Attn: Kendra Spergel, Grove City Development Department

From: Phil Moorehead, Faris Planning & Design

Re: Application #201610310076 – Trivium Development responses to Staff Report dated November 18, 2016 for Trivium Grove City MOB Final Development Plan application

EXHIBIT I-3

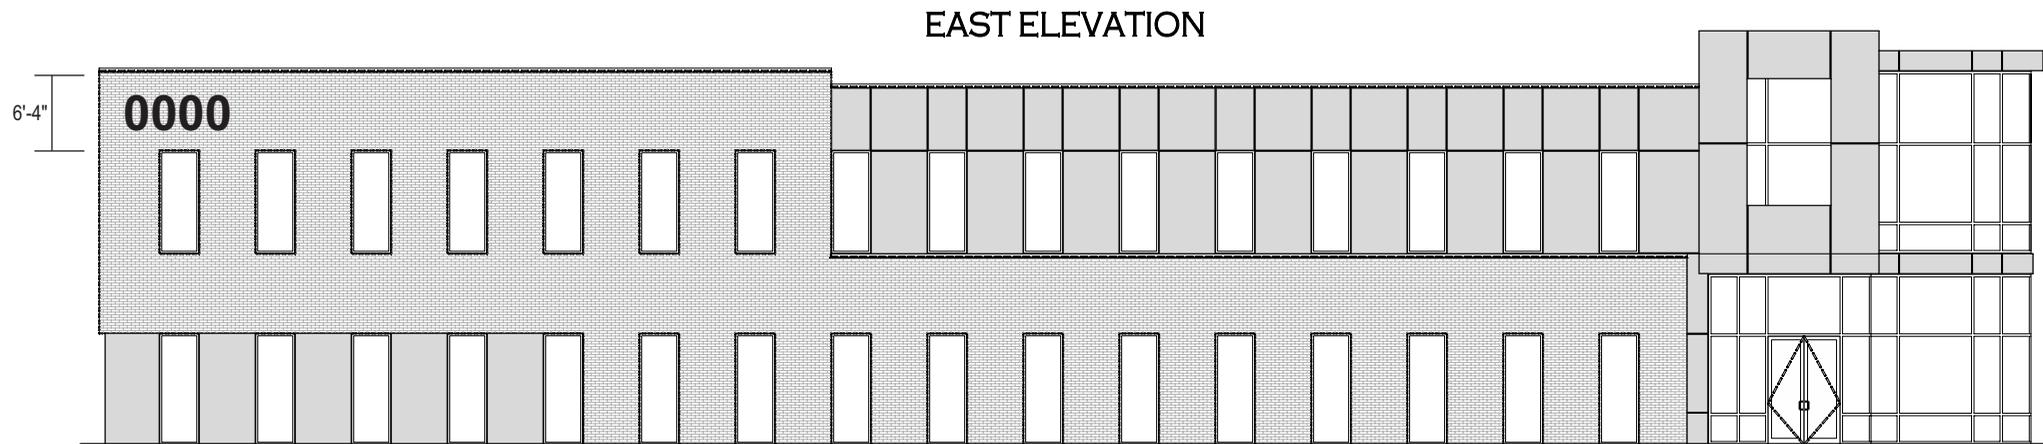
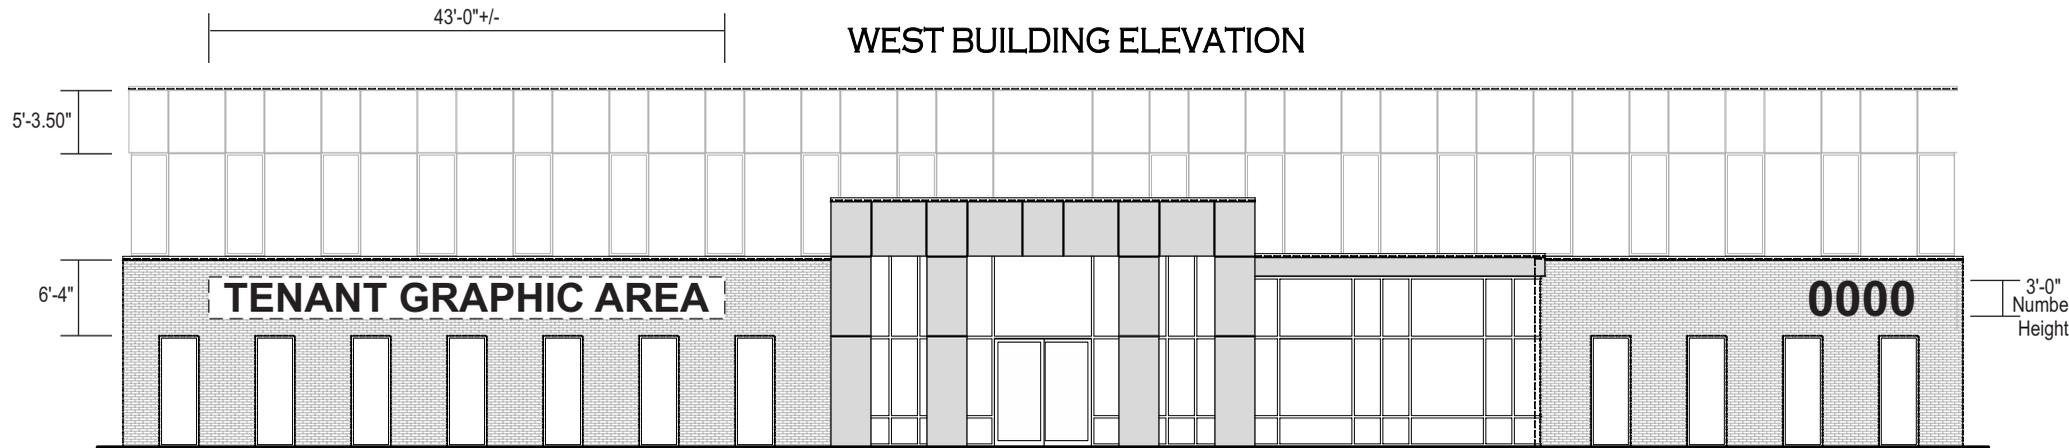
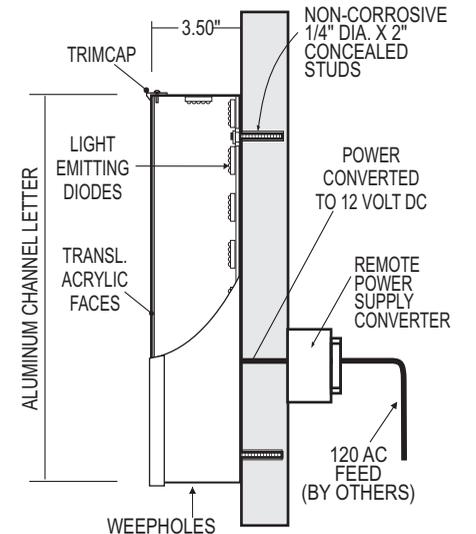
3. Details for all proposed signage should be submitted, including all wall signage and monument sign. Please note that signage is approved as part of the development plan and any details not submitted with the development plan will require a separate development plan approval.
 - a. Any monument signage on the site should have a brick base to match the brick utilized on the primary structure.
 - b. Only one monument sign should be located on the site and highway signs are not permitted per Section 1145.17(a).

RESPONSE: Details for all proposed signage has been provided, and all signage will utilize a brick base to match that on the primary structure. See Exhibits I-1, I-2, and I-3 for more information on signage.

EXHIBIT I-2

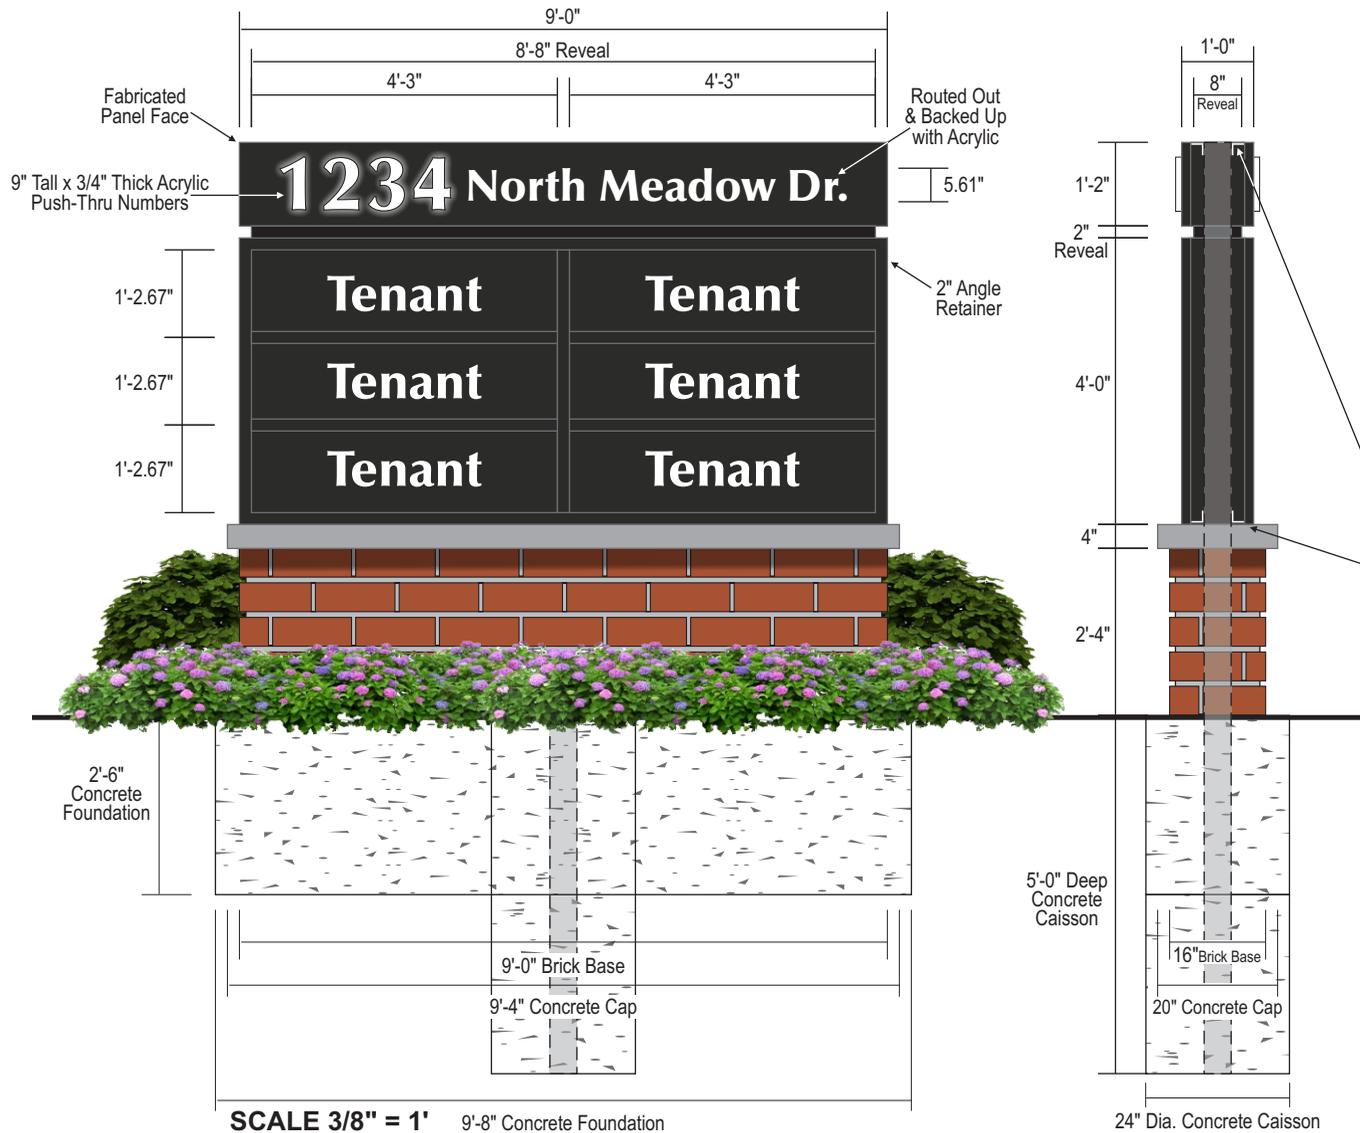
4. Freestanding signs are required to be set in landscaped areas per Section 1136.09(a). The landscaping area needs to be at least two (2) feet larger than the sign's foundation and contain landscaping on all sides with permanent shrubs, groundcover, or other ornamental plantings. Annuals and perennials may be used, but in combination with the permitted permanent plantings. A detail for the sign's landscaping should be provided.

RESPONSE: Detailed landscape plans in conformance with Section 1136.09(a) have been provided for all proposed freestanding signs. See Exhibit D-1 for more information.
